## PRODUCT CHANGE NOTIFICATION

#PCN-DC-G9FC-12

### Description of Change:

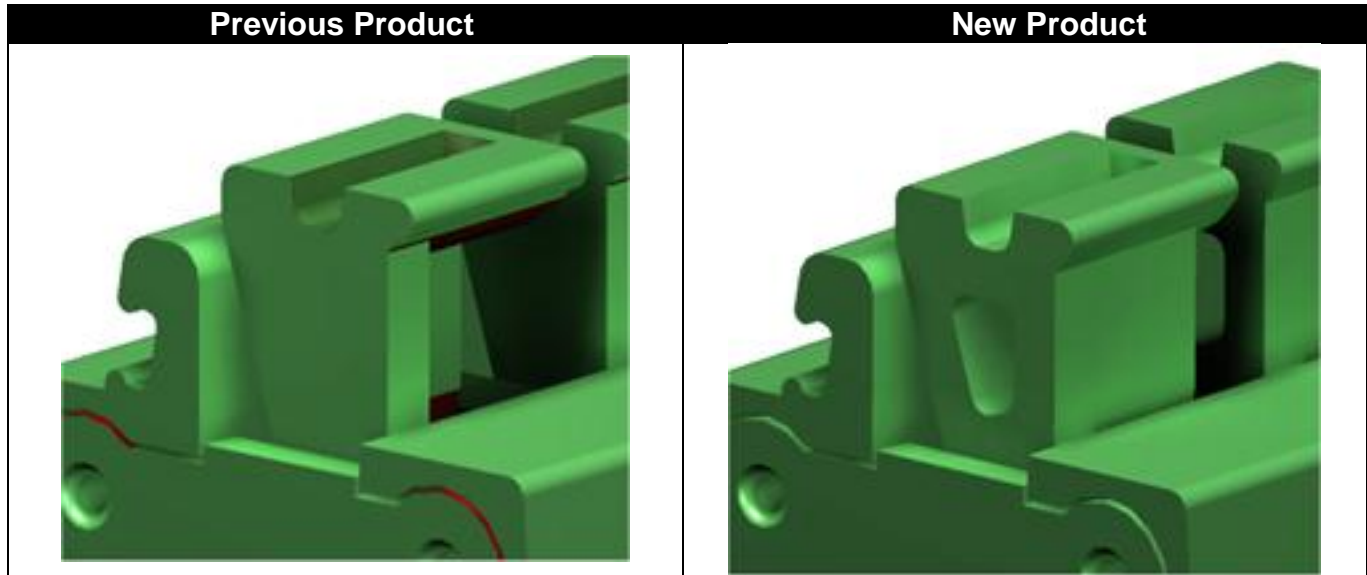
With the original shape of the PTS 1,5 release button, there had been a tendency to pull the release button out of the terminal in order to open it. As a result, the terminal block could no longer be opened. In order to eliminate this problem, the shape of the release button will be changed to a smoother surface. (see pictures below).
